**RE: State Employees Federal Credit Union
Grading and Drainage Plan
Engineer's Stamp Date 10-19-16 (File: F16D001)**

Based upon the information provided in your submittal received 10-21-16 (Drainage Report dated 9-15-16), the above-referenced plan is approved for Site Plan for Building Permit. It is also approved for Building Permit with the following condition:

RE: Revised grading Plan for building Permit
Lot G2A1 Montgomery Complex

GRADING
AND DRAINAGE PLAN

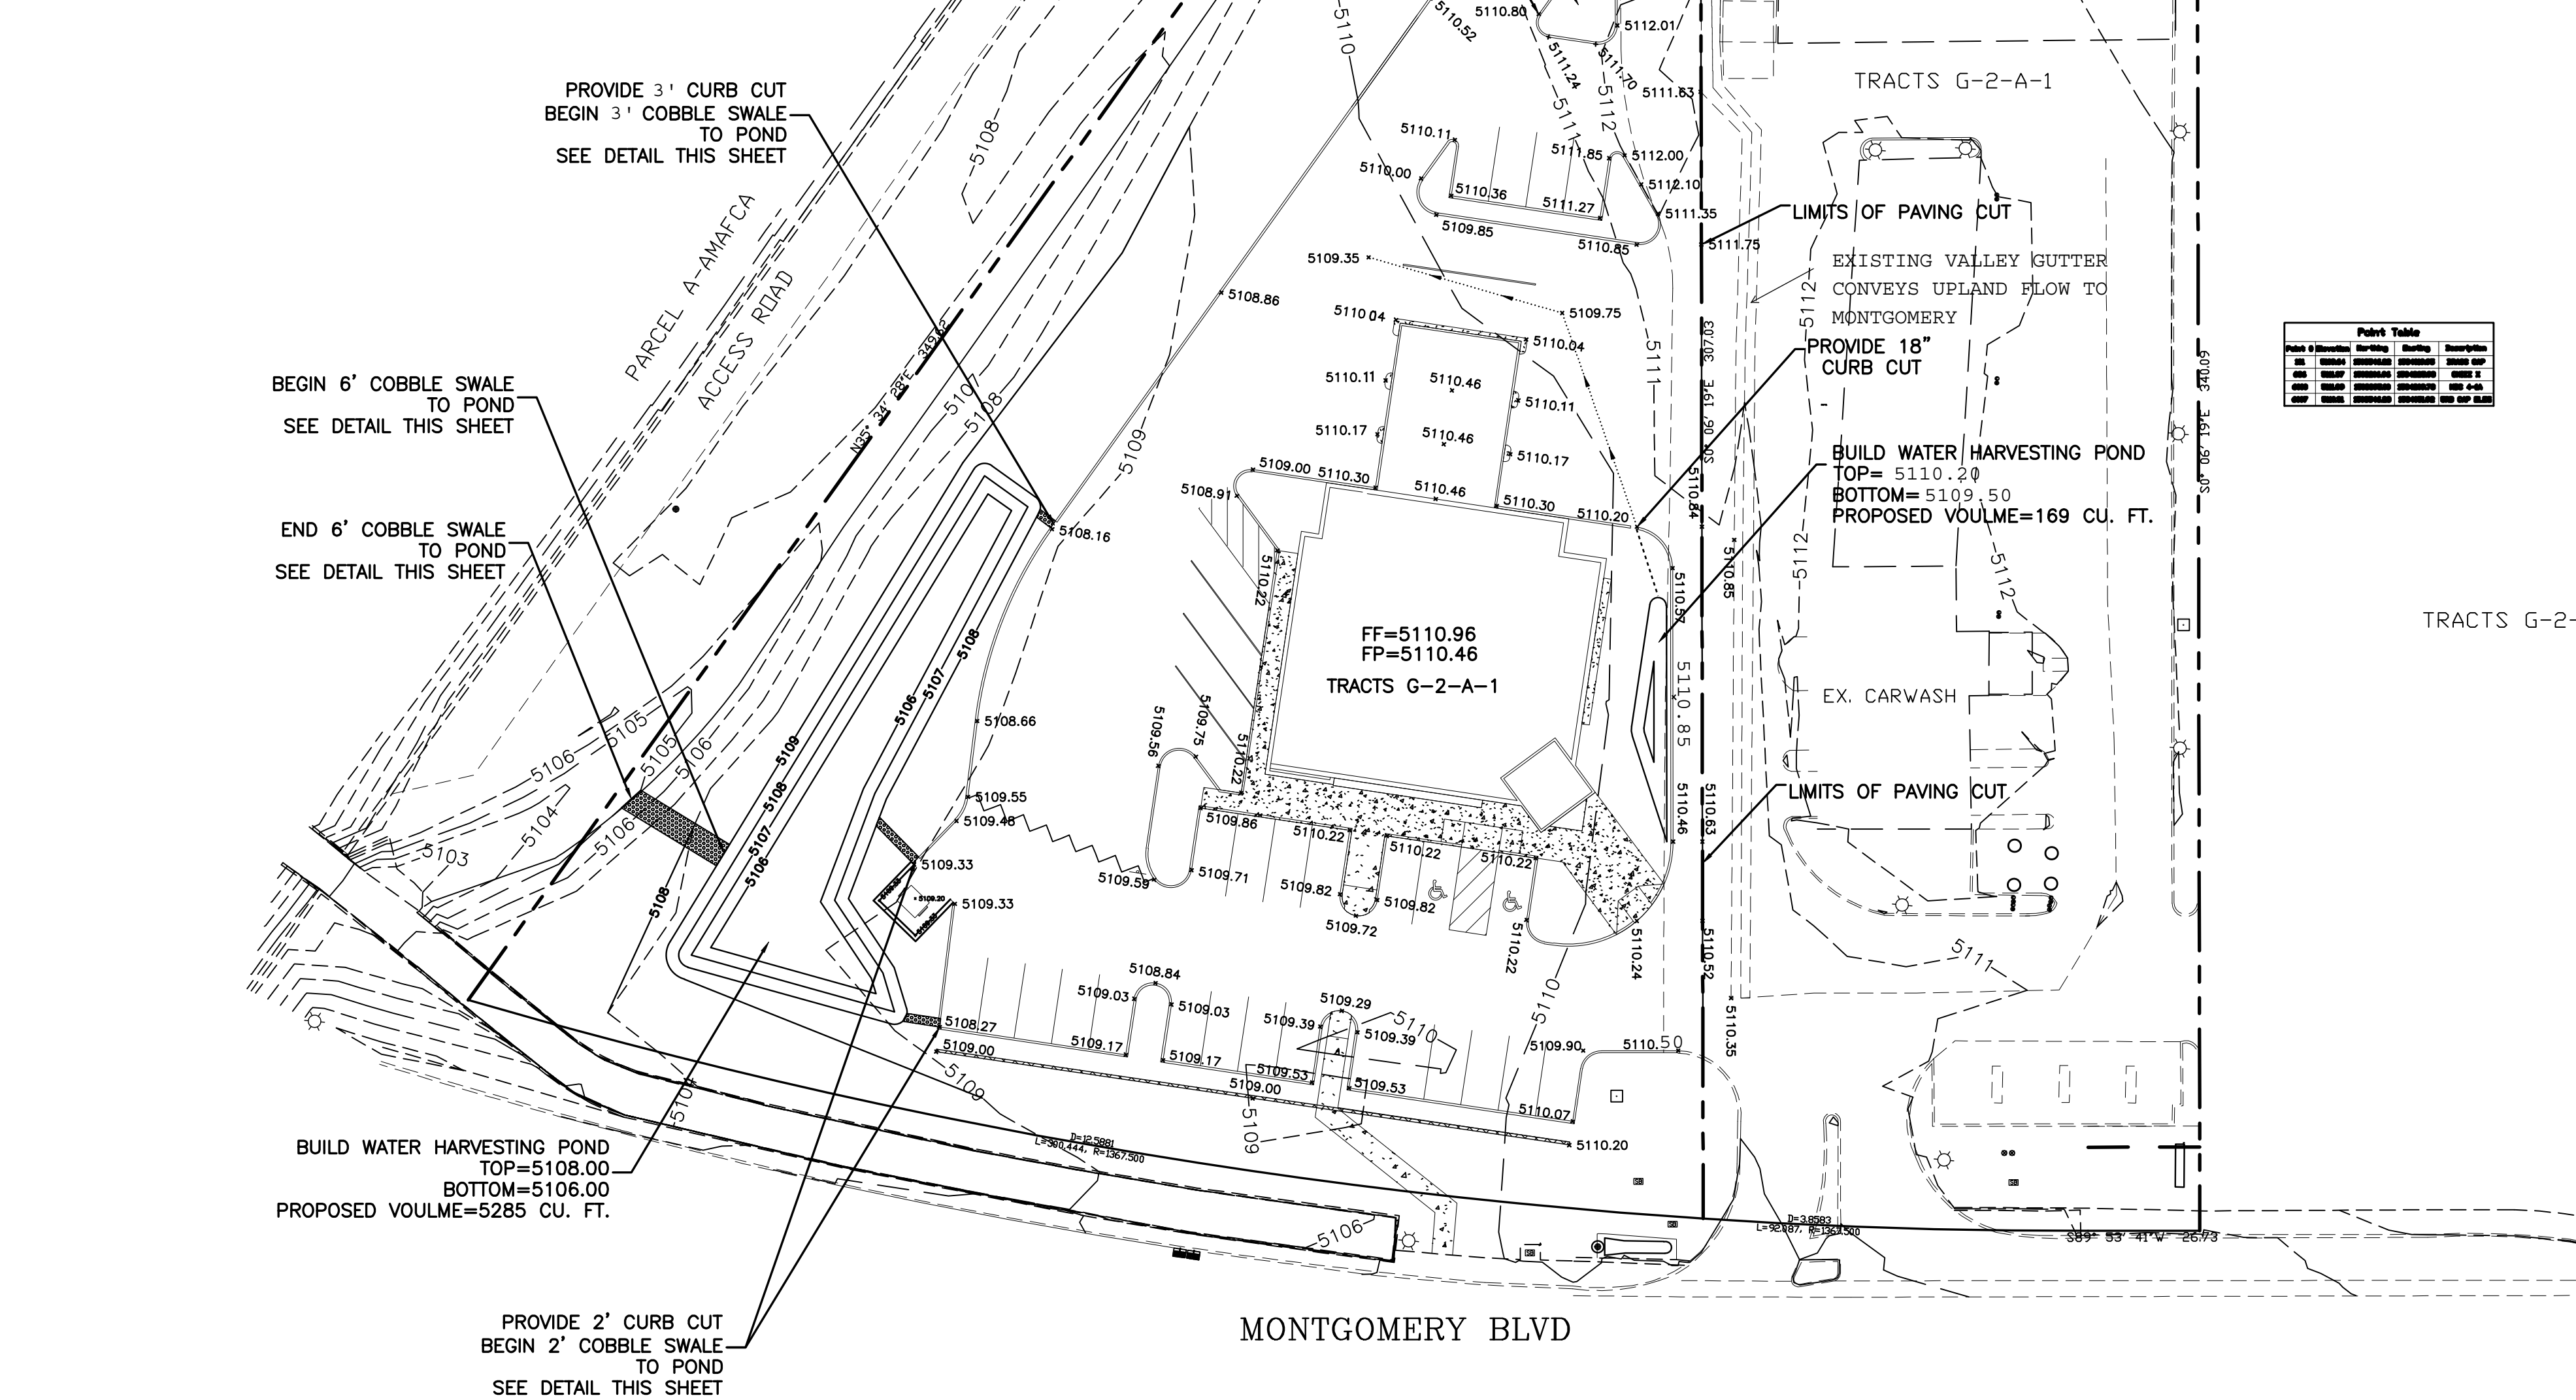
1. The comments from AMAFCA regarding the outfall from the pond into and within their property will be approved through a turnkey agreement. The constructed improvements will need to be approved prior to approval for Occupancy.

Rio Grande Engineering has revised the enclosed grading plan to incorporate AMAFCA comments regarding access to the channel as well as the nature of the out fall. We have included an outfall structure preferred by the city. The outfall has been designed to allow for 1824 cubic feet of water quality storage, which exceeds the 1,097 cfs (38,700x.34/12) required.
